ISB Information Letter 14-1  
Sequence No. 8  
November 10, 2014

TO: Cummins Mailing List  
SUBJECT: Corrected Annotation of FIG. A4.7

(Revises D 7484-13a)

FIG. A4.7 Location of Sensor for Intake Manifold Temperature Measurement

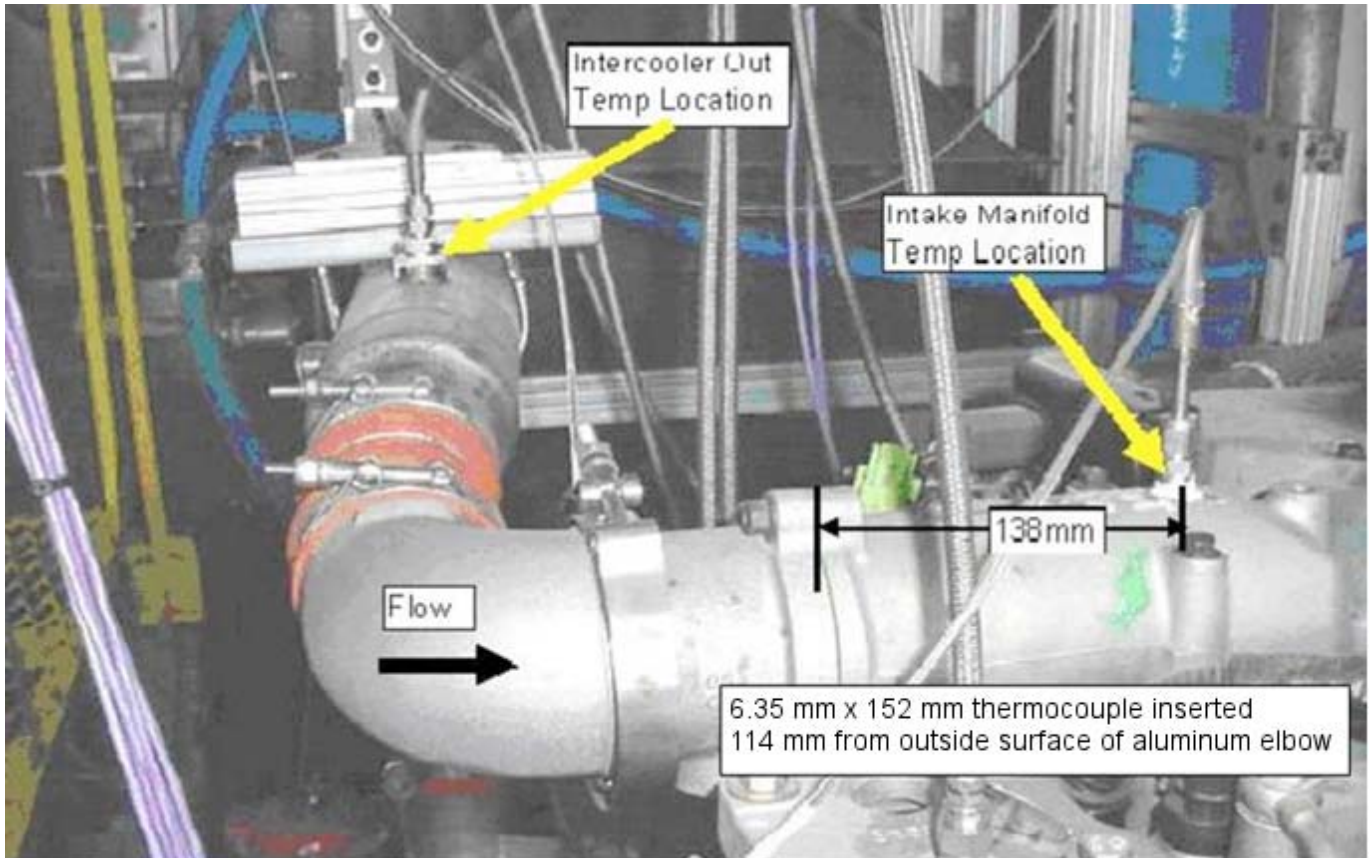
It was discovered that there was an error in the annotation of FIG A4.7 describing the insertion depth of the thermocouple in the intake piping of ASTM Test Method D7484. FIG A4.7 has been updated to correct the error and is attached.

Replace FIG. A4.7
